ADDENDUM NUMBER: ONE (1)

TITLE: 1412027246 (IFB) Construction for Nocatee T2 Addition

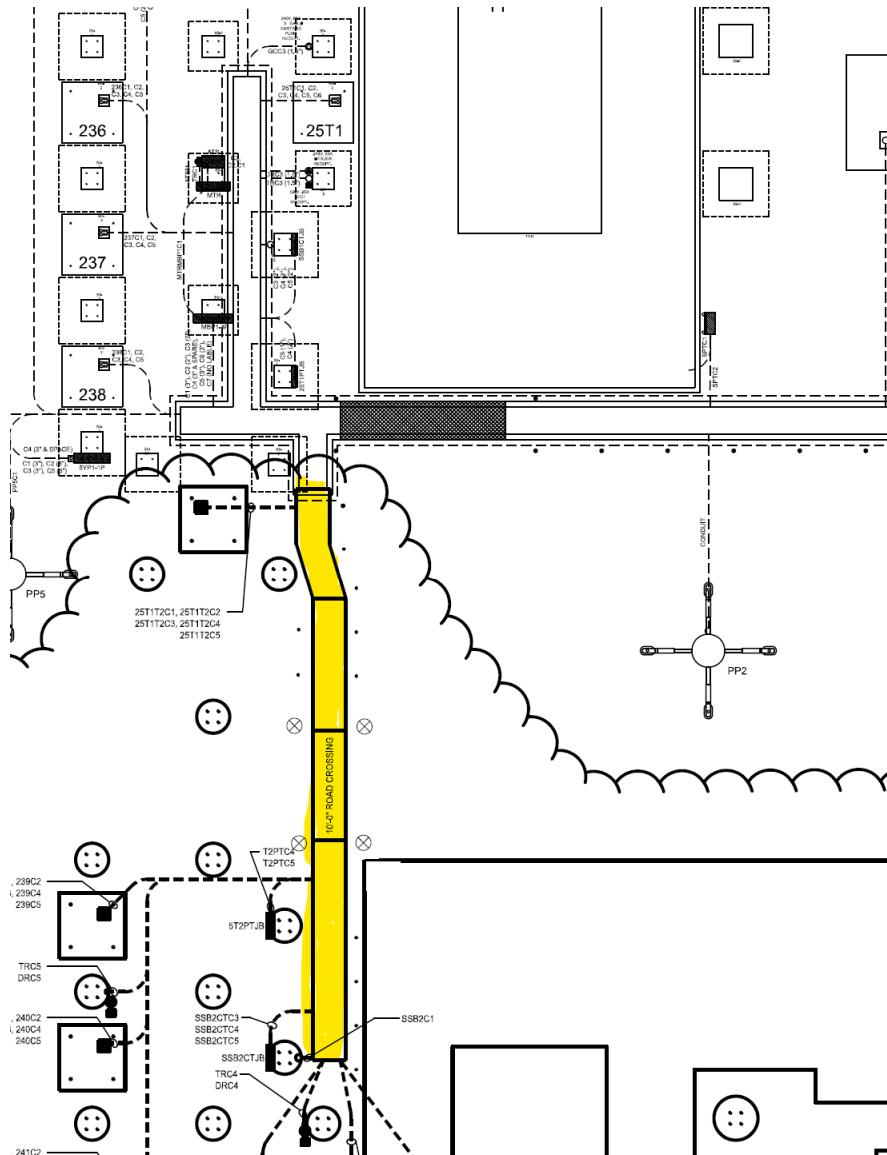
9. **Clarification:** The new cable trench is shown in the highlighted section below and represents the only new trench section to be installed for this project. The contractor shall furnish all cable trench materials and install them in accordance with the drawings.
